CLIENT K.C. GILLET

FIR TREE COTTAGE
CHURCH PATH
HOOK
HAMPSHIRE
RG27 9LY

Development Design By

SOUTH ELEVATION 1/100

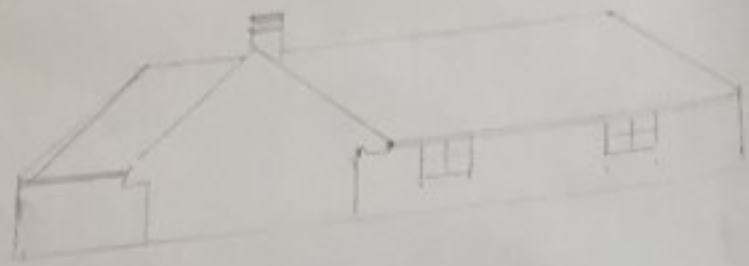
? IF THE ROOFS ABOVE DOORS CANNOT BE CHANGED WOULD IT BE SENSIBLE TO SLITLY LOWER GROUND LEVEL TO STEP UP INTO DOORS, SURFACE WATER CAN BE TAKEN AWAY TO A NEW SOAKAWAY!
